State of New Mexico  
Energy, Minerals and Natural Resources

30-015-27340

Continental A State

SUNDRY NOTICES AND REPORTS ON WELLS

LEASE NAME	Continental A State
WELL #	13
API #	30-015-27340
COUNTY	Eddy, NM

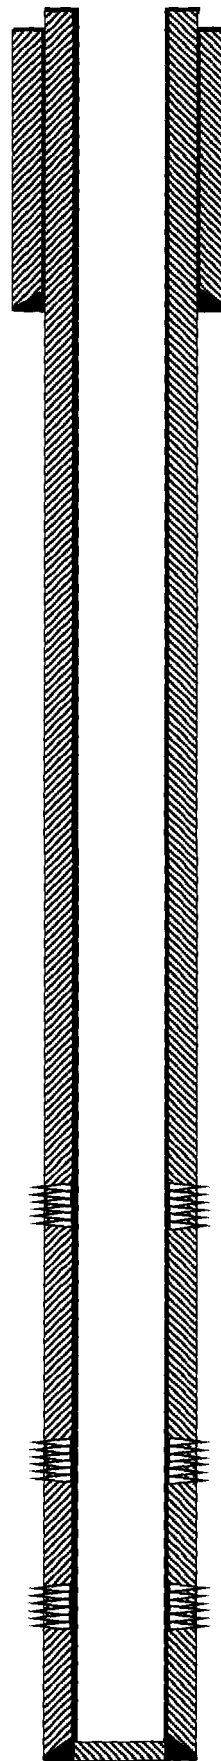
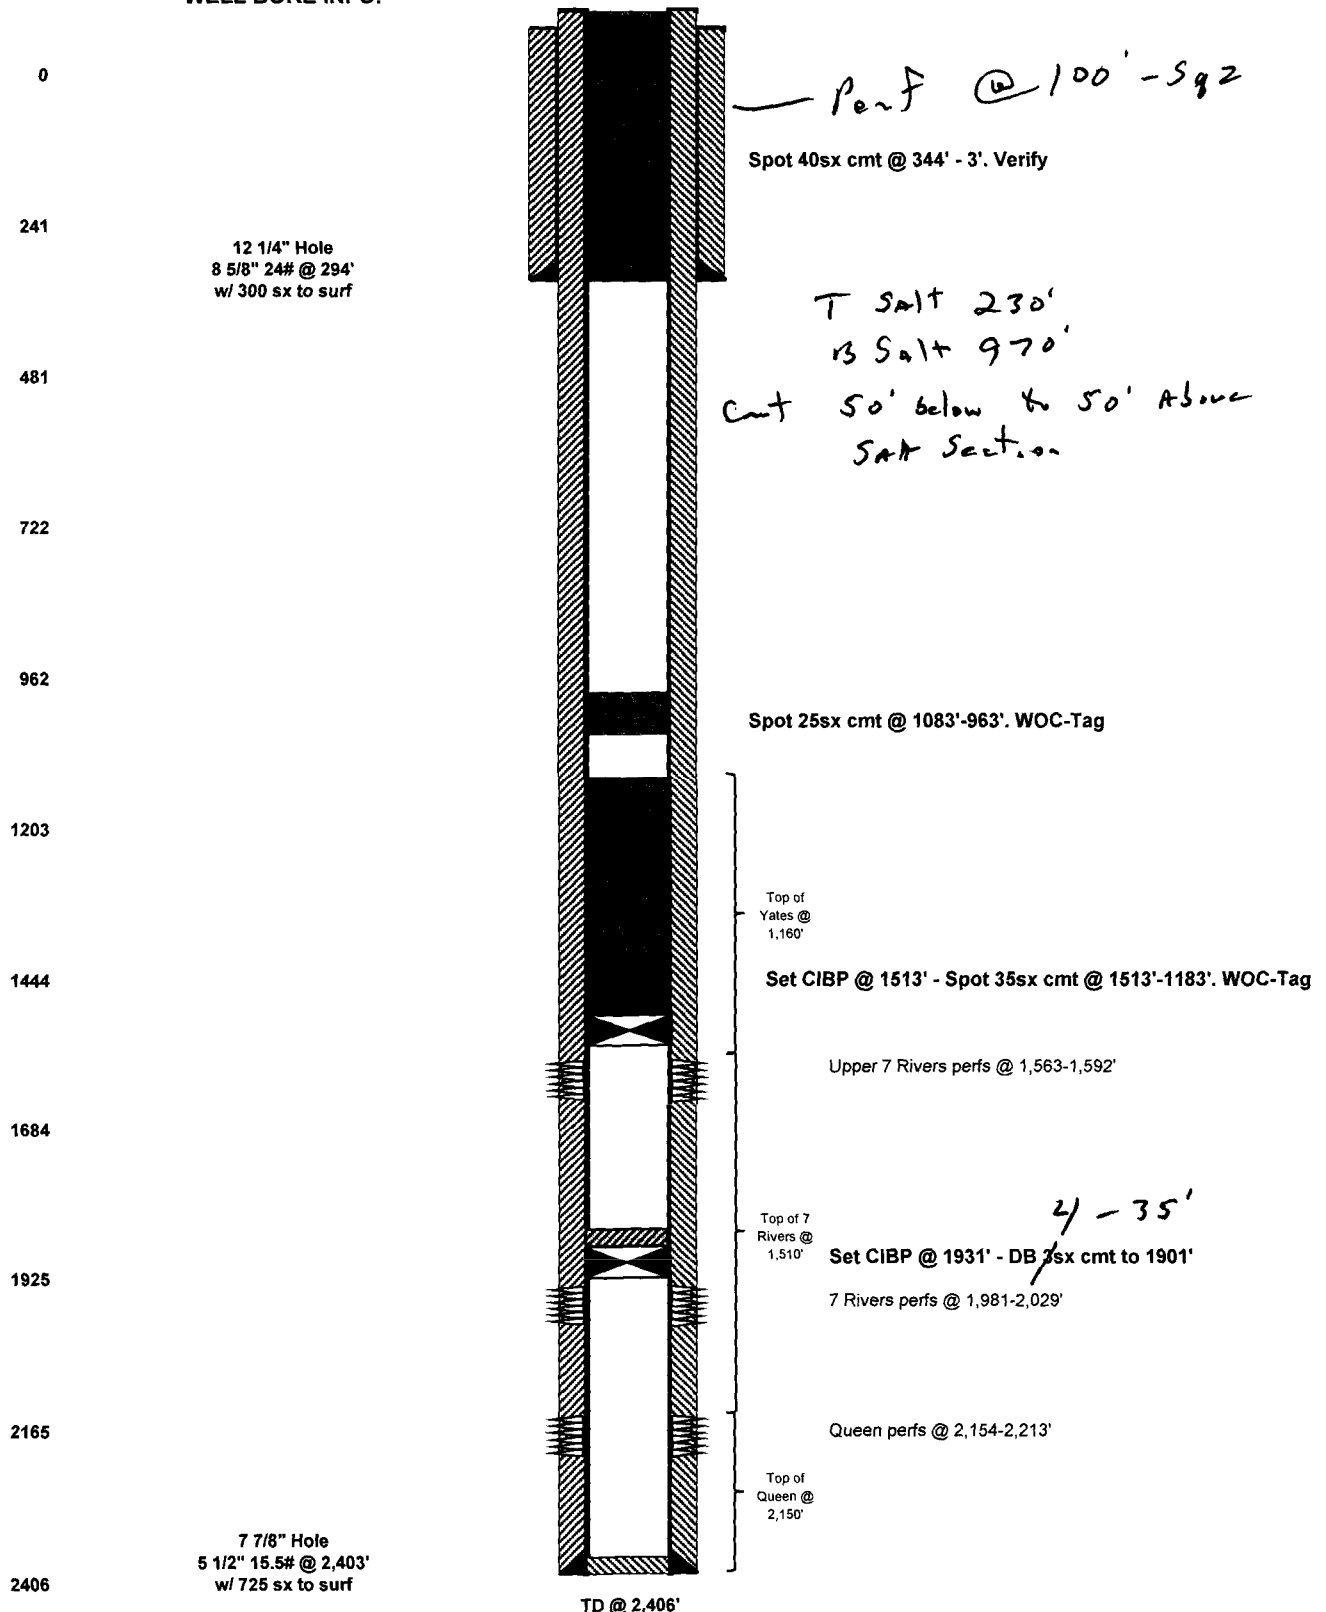
- MIRU. ND WH, NU BOP 4' 35'
- Set 5 1/2" CIBP @ 1,931'. Dumpbail 3 sxs @ 1,931' - 1,901'.
- Set 5 1/2" CIBP @ 1,513'. Circ well w/ MLF cap BP w/ 35 sxs @ 1,513' - 1,183'. WOC-Tag
- Spot 55 sxs @ 1,083' - 963'. WOC-Tag T 5m + 230'
- Spot 40 sxs @ 344' - 3'. Perf @ 1000' - Attempt 4 sxs 2. 3 Salt 970'
- Verify cmt @ surface. Top off if necessary. RDMO. Cut off WH & anchors & install DH marker.

\* See Attached COA's Must Be Plugged by 2-27-19  
I hereby certify that the information above is true and complete to the best of my knowledge and belief.
